**Subject: Fwd: Comment and objection for Planning Application 13 Chalcot Gardens:  
(2024/4823/P)**

Flat Lower Ground Floor 13 Chalcot Gardens London Camden NW3 4YB

Proposed replacement Outbuilding (Garden Studio) within the rear garden.

Figure 1. Garden Studio Proposal and scale as shown in application. (Ref pg. 11)

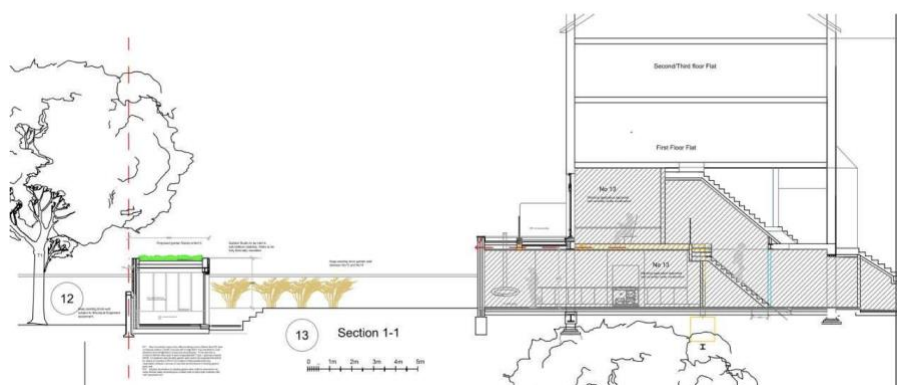
The Garden Studio is set 10m from the main residences and facing the residences and as outlined in Policy A1 Section 2.4 this condition is not met. Further to this the nature of the low boundary walls, which is in the character of the Conservation Area and Gardens, will mean inevitable overlook. Please see Figure 1 below for reference of distances as per application.

Figure 2. Overlook of garden building and proportionality to surroundings in vicinity.

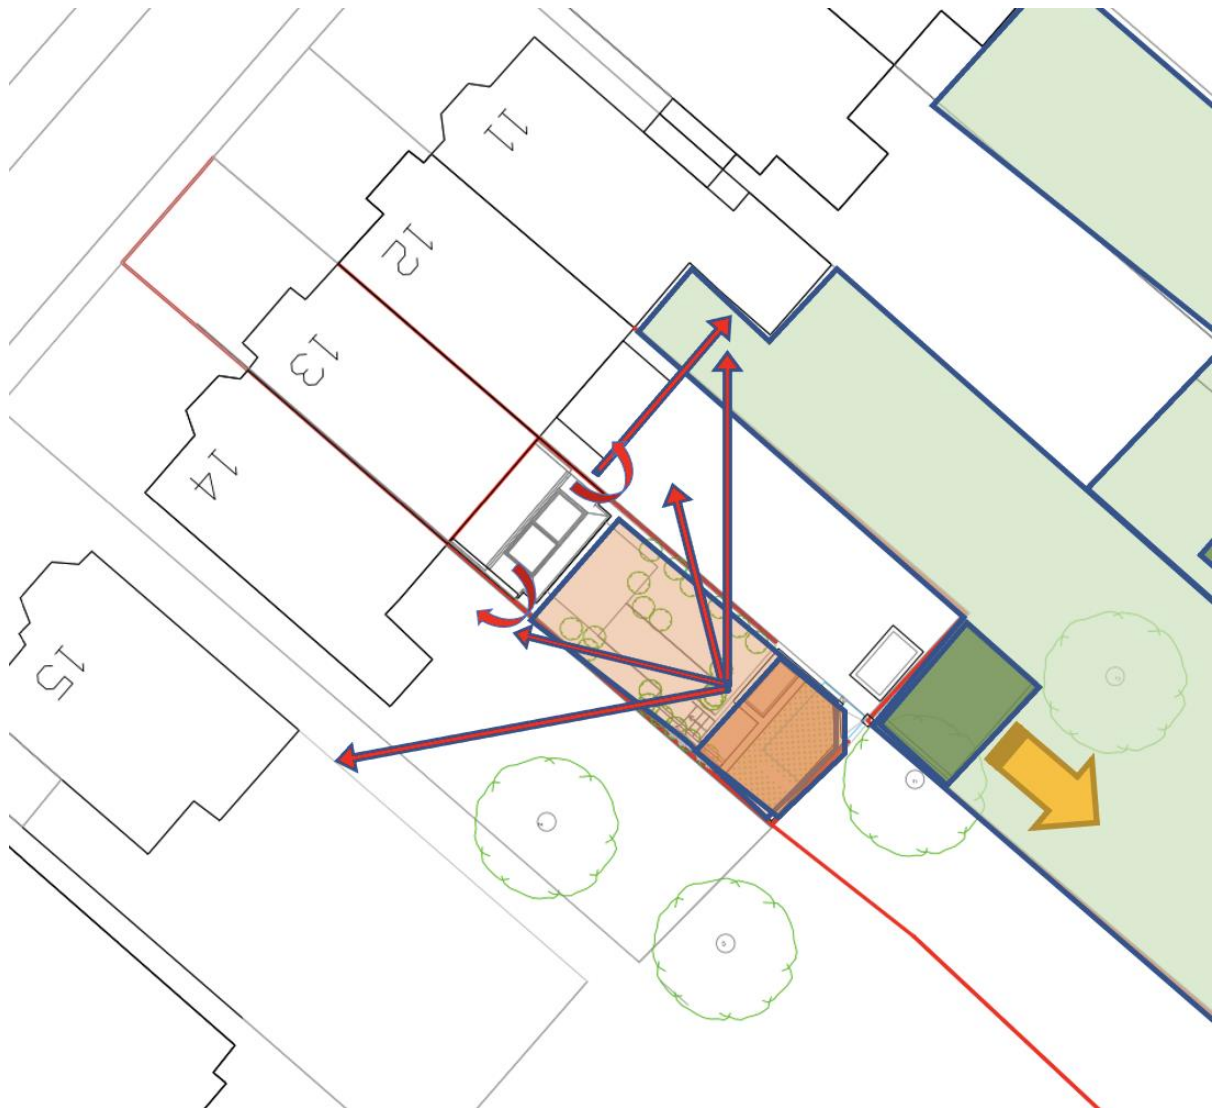
This statement needs to be reviewed more carefully. In the case of the garden buildings at No9 and No11 the owners have shown due concern and consideration for residents by facing windows and doors face away from the main residences and do not overlook the residential properties. In the case of No5 the garden building is set considerably further back, approximately 40m away from the main residence and is surrounded by large trees.

As shown in Figure 2 it should be noted that Outbuildings windows/sliding glass doors in No. 9 and No.11 do not overlook or face the buildings and windows of the neighbouring residences allowing for their preservation of privacy.

The outbuilding in No.5 is set significantly further back, approximately 40m away and surrounded by large trees which along with the depth provide significant amounts of privacy to neighbouring residences.

In the case of all the outbuildings referenced as a precedent, they are all set considerably further back in the gardens than the proposed development.

In relation to size and proportionality please refer to Figure 2. As can be seen all the “similar” garden buildings used to set a precedent sit in significantly larger gardens. They all benefit from gardens that are multiple times larger than 13 Chalcot Gardens. Their outbuildings’ relative size

(smaller than the proposed Garden Studio) to their gardens, direction of outlooks and significantly greater soft landscaping & large trees makes them a poor comparative reference point for the acceptability of this proposal. The proposed garden Studio at 13 Chalcot Gardens would use 25% of the available garden relative to less than 10% of the gardens in No. 5, No. 9, and No. 11.

*Figure 5. A large portion of the boundary wall is raised.*

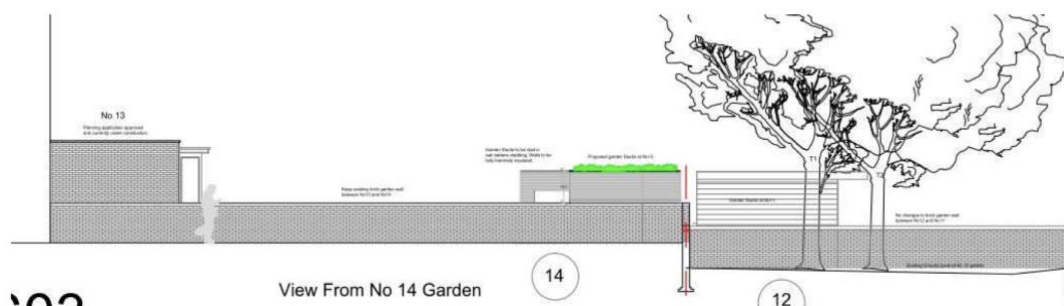
Further to the erosion of the garden space the erection of high walls on either side take away from the character of the conservation area defined by low boundary walls which allow for a sense of openness and the free movement of local wildlife (see Figure 5). The Garden Studio proposal is also wall to wall and effectively hermetically seals the Garden in no. 13 from the other gardens impacting the nature of the conservation area and the movement of wildlife (see Figure 6). The above statement is echoed in the Official Planning Guidance on Design : Paragraph 4.41 of which the sections states:

*Figure 6. Wall to wall extensions seal off the garden from other and raise boundary walls.*

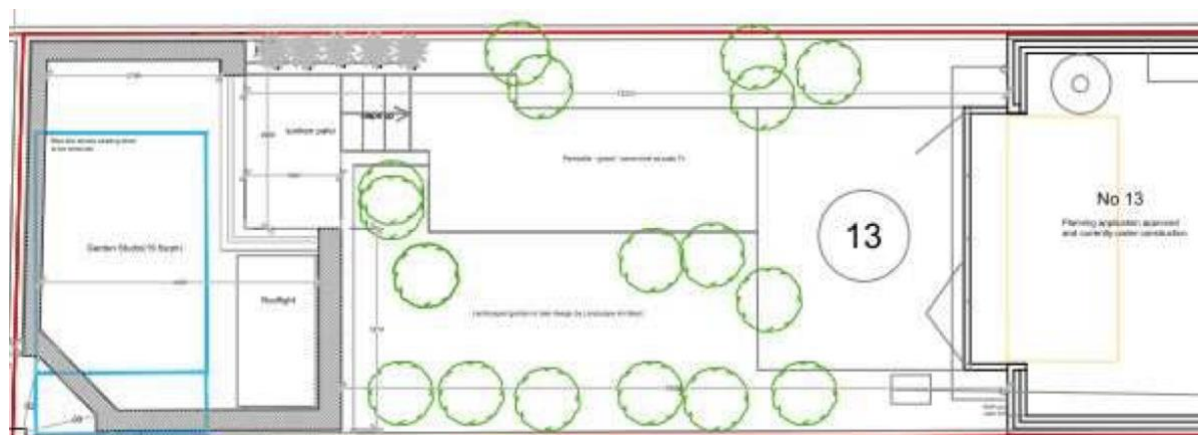
As noted in Figure 6 the Garden Studio proposes to build walls end to end hermetically sealing off No 13 between the 4m extension and the Garden Studio. This will stop the natural movement of wildlife and create a dead zone of concrete, glass and light.
